**BRIDGE PROJECT
TOWN OF MORRISTOWN
COUNTY OF LAMOILLE
CADYS FALLS ROAD (T.R. #2) MAJOR COLLECTOR
BRIDGE NO. 8**

MORRISTOWN
BF 0239 (3)

DRAWING COVERS	
PROJECT	MORRISTOWN BF 0239(3)
LOCATION	CADYS FALLS ROAD over LAMOILLE RIVER
ENGINEER	VERMONT AGENCY OF TRANSPORTATION
CUSTOMER	BLOW & COTE, INC.

DRAWING COVERS	
BRIDGE RAIL ASSEMBLY	
PROJECT	MORRISTOWN BF 0239(3)
LOCATION	CADYS FALLS ROAD over LAMOILLE RIVER
ENGINEER	VERMONT AGENCY OF TRANSPORTATION
CUSTOMER	BLOW & COTE, INC.

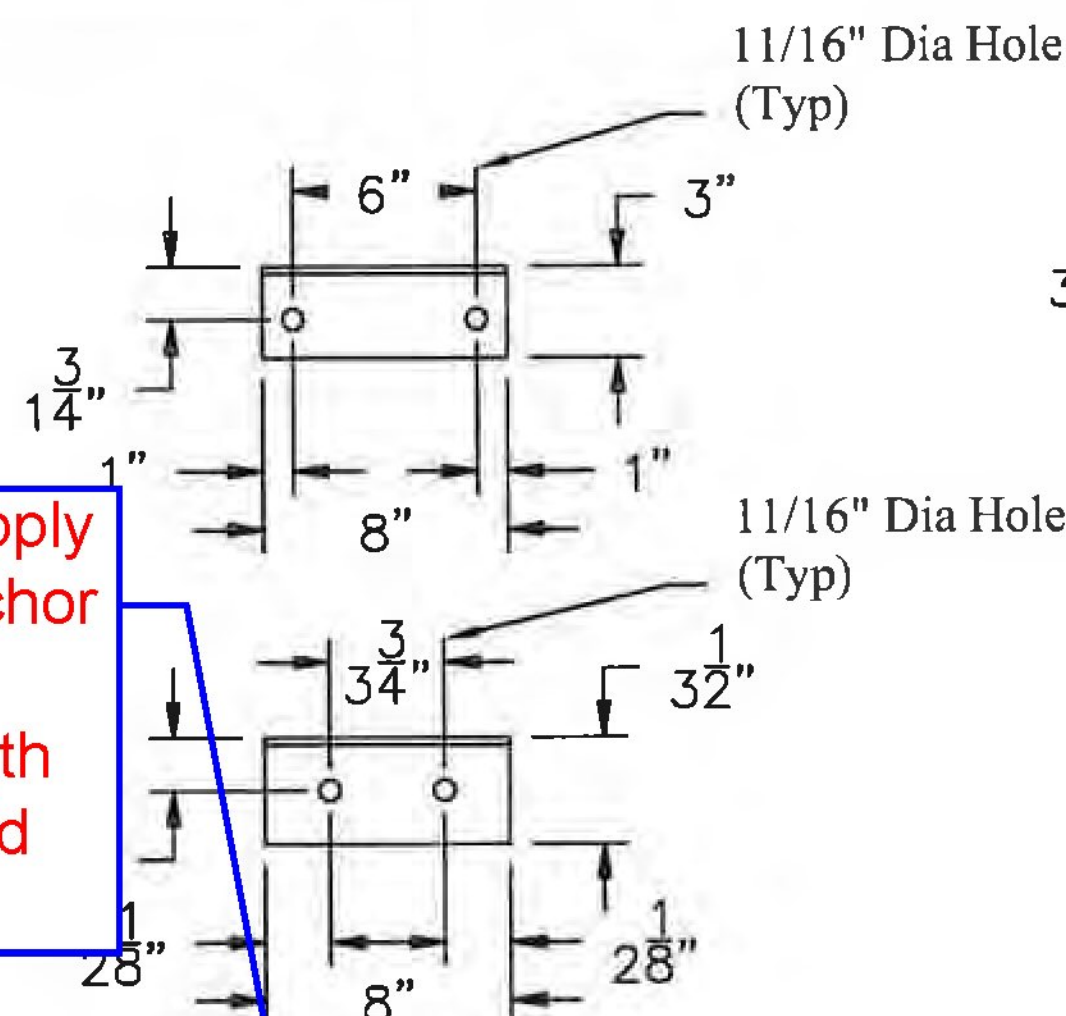
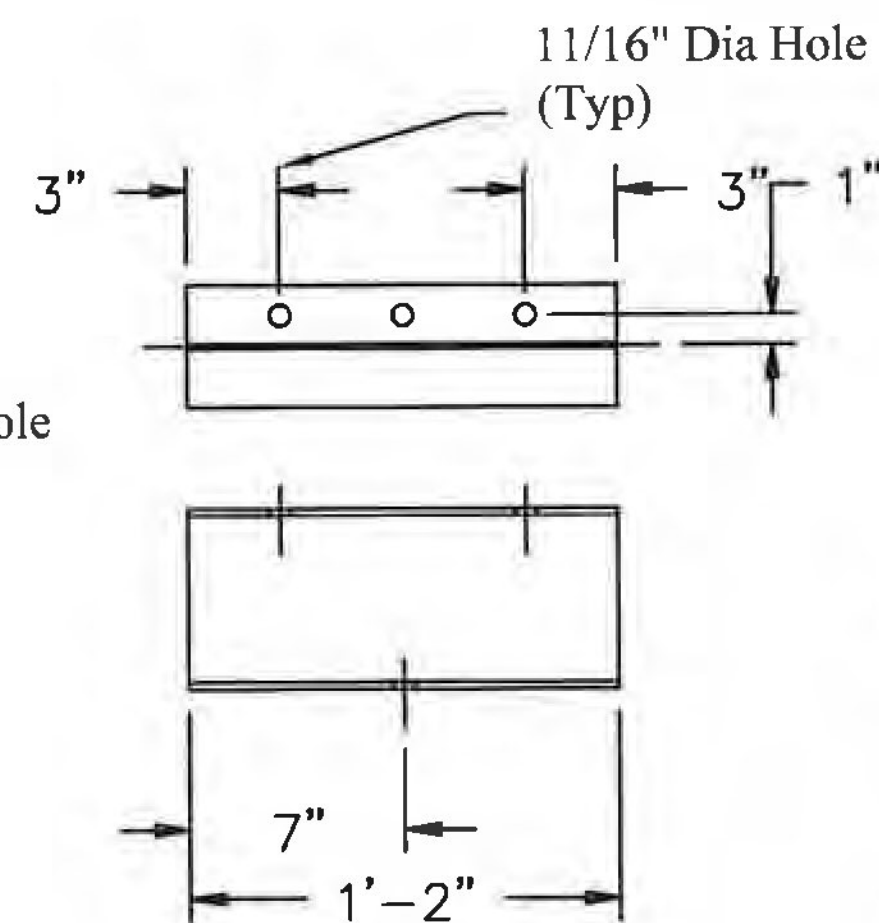
Contractor to supply threaded rod anchor details with embedment length and ultimate bond strength

DWG:  
FIT

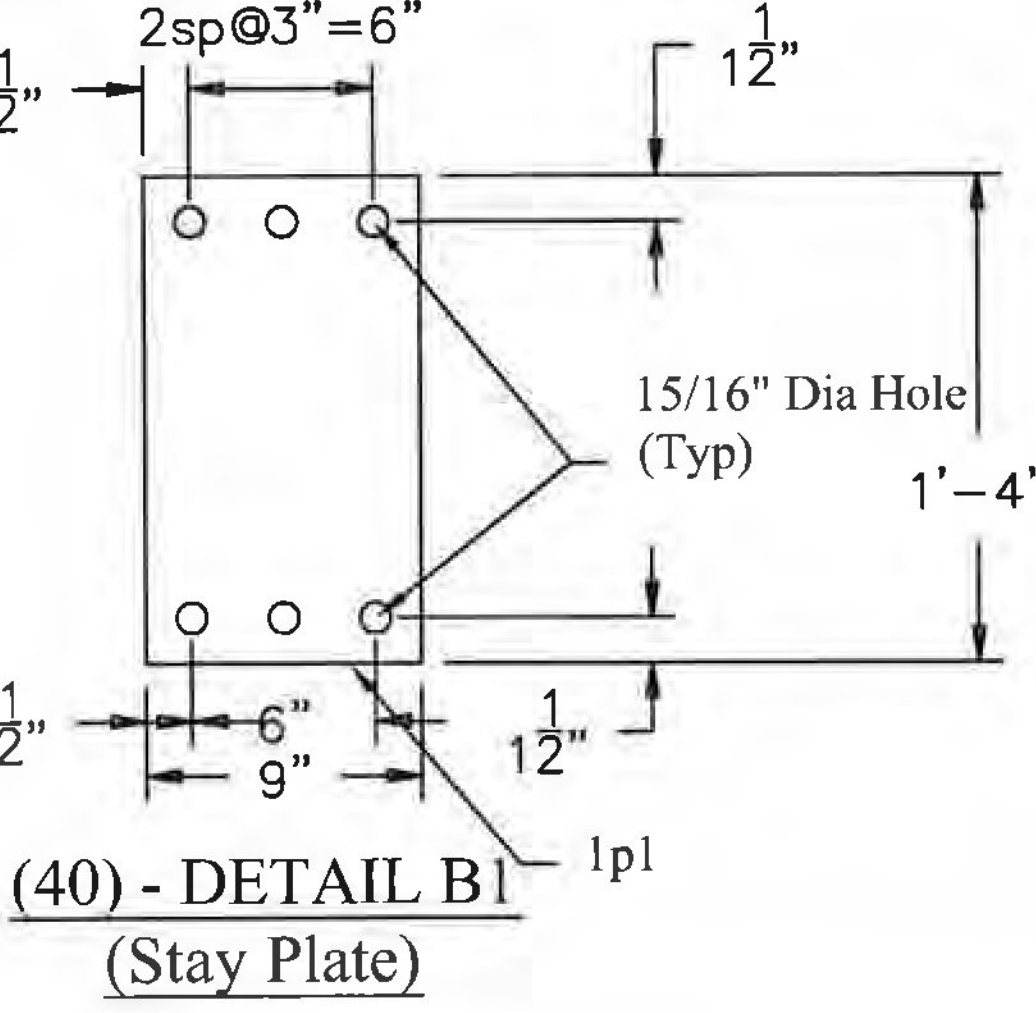
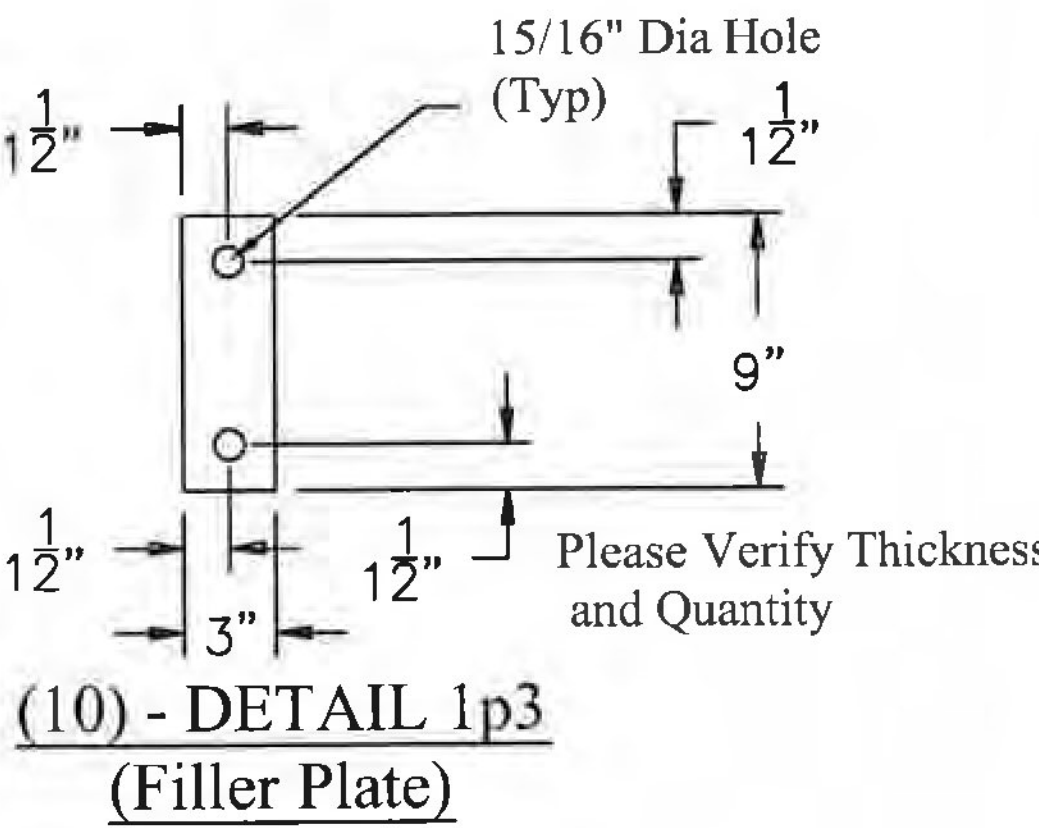
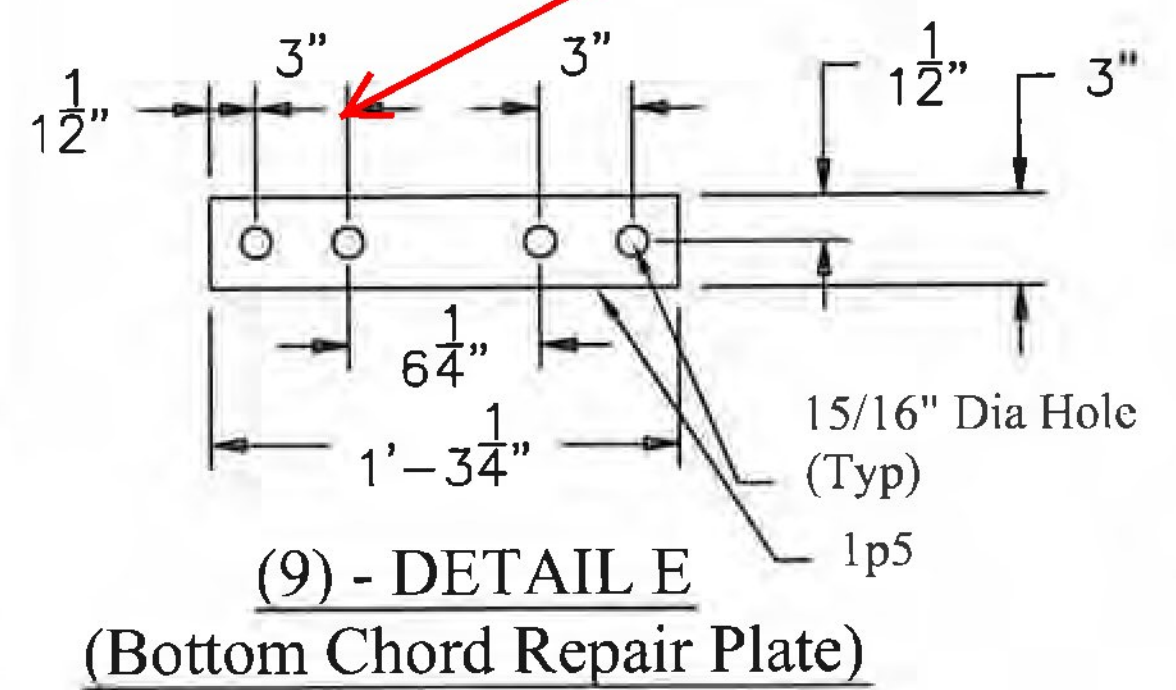
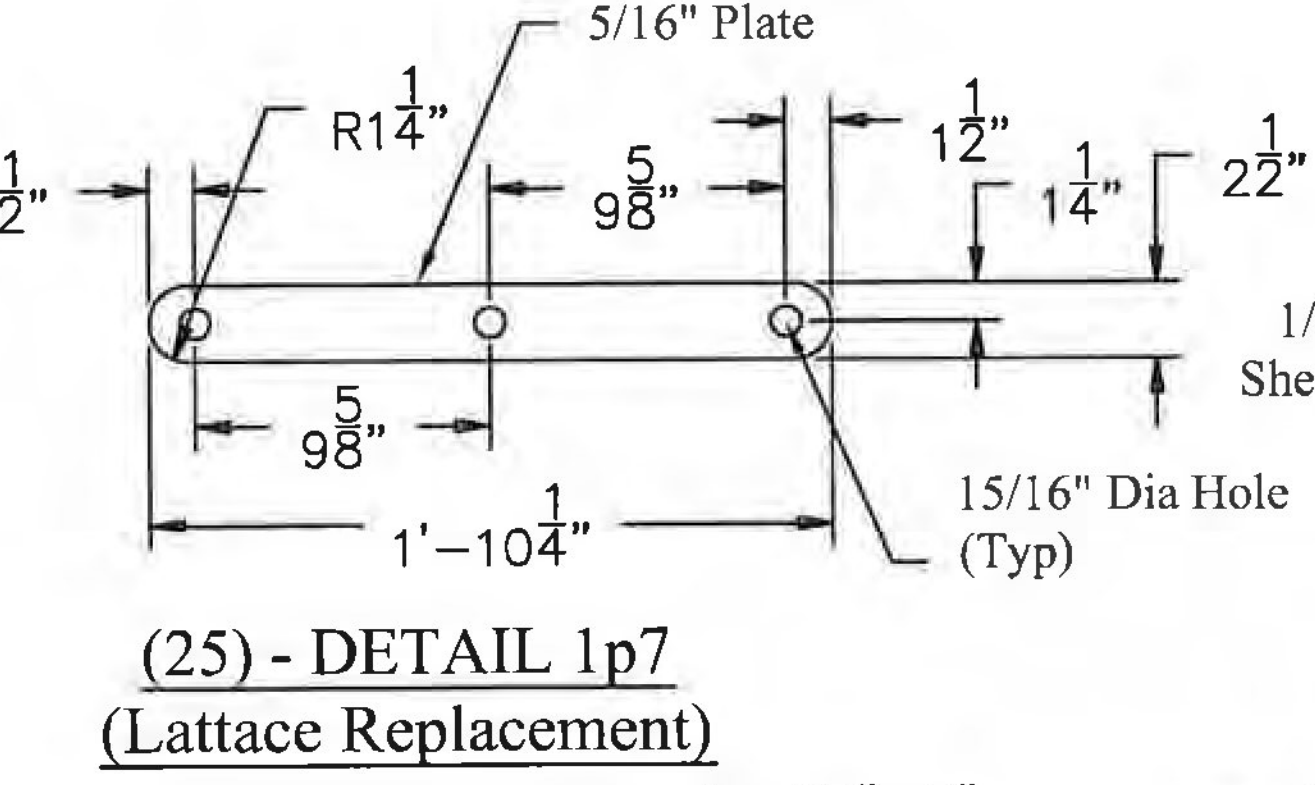
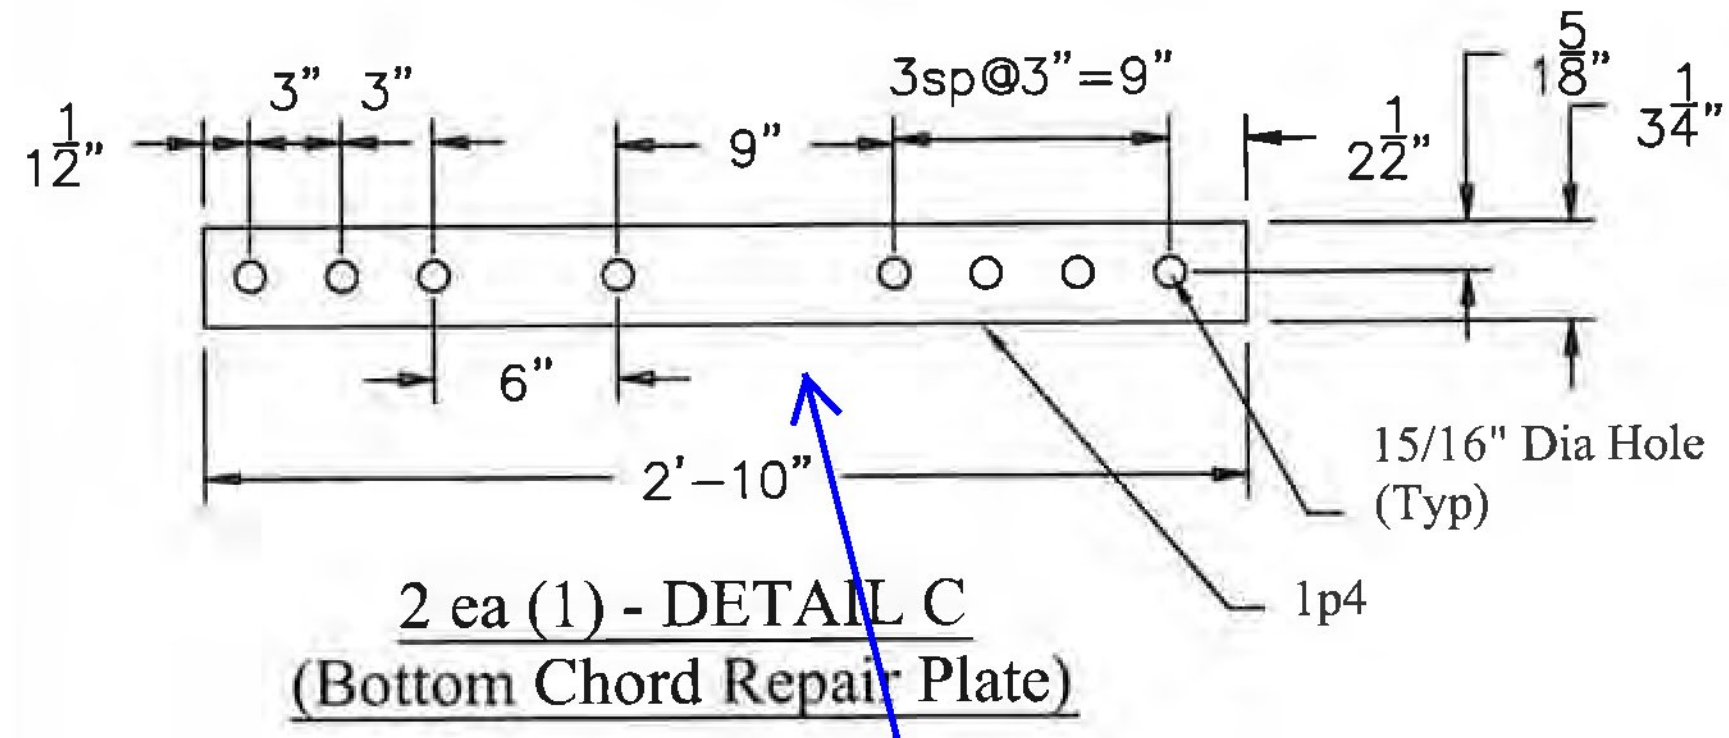
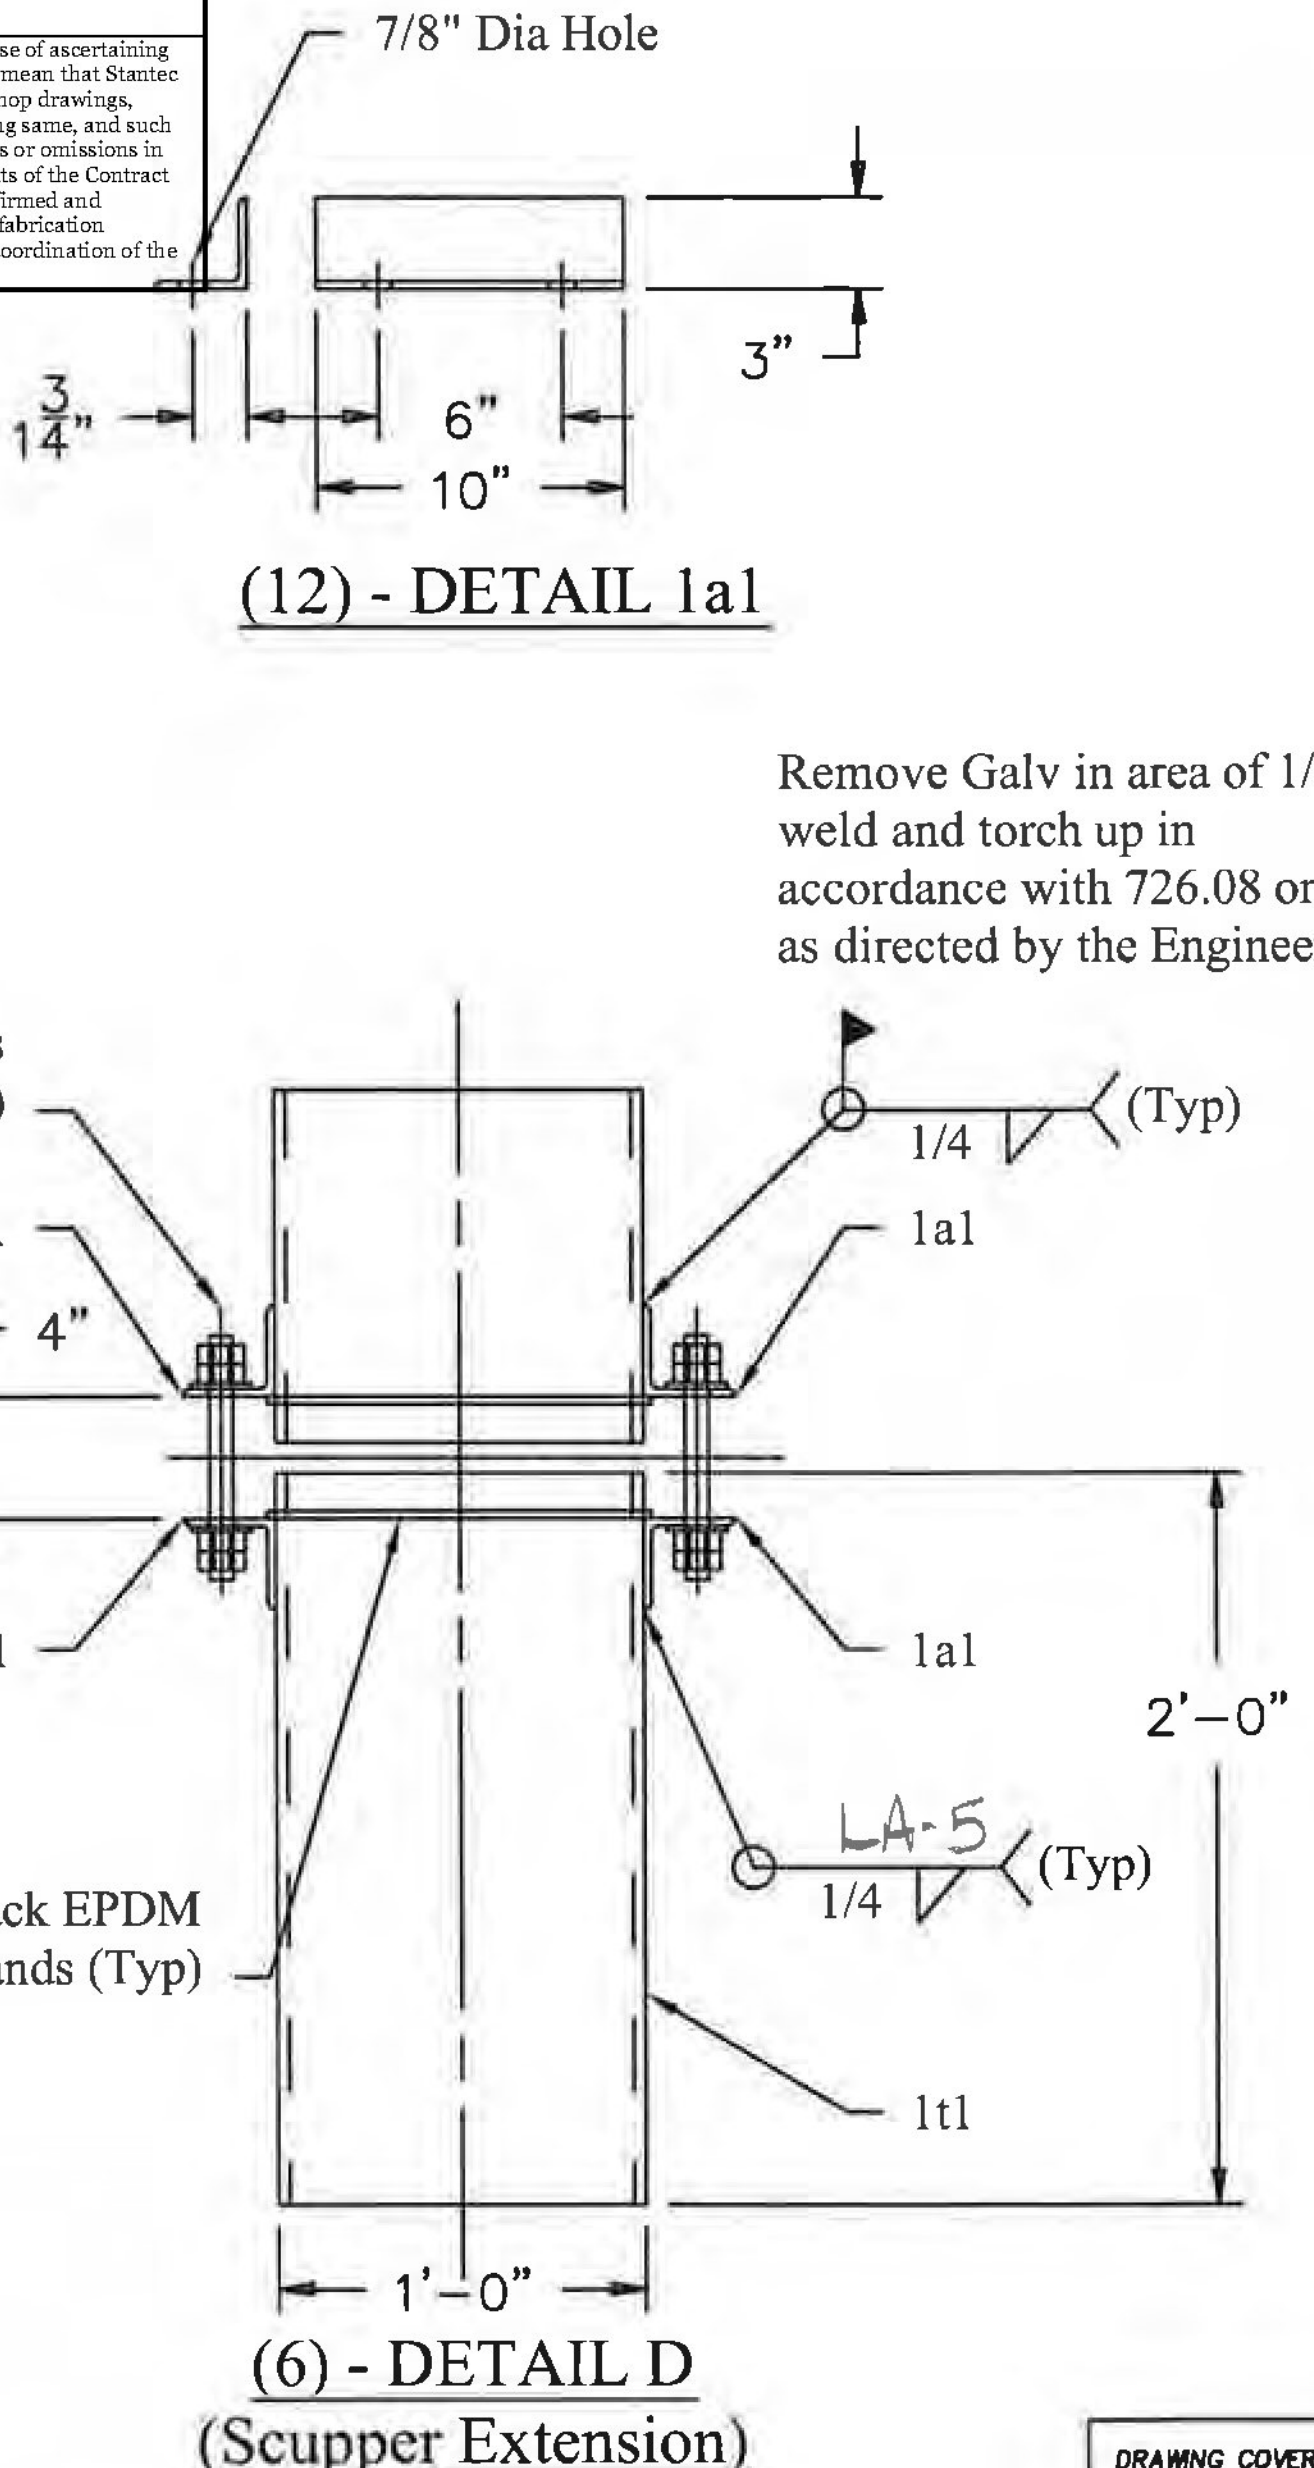
Sizes and dimensions to be verified in field by contractor

Plate size to be confirmed by others
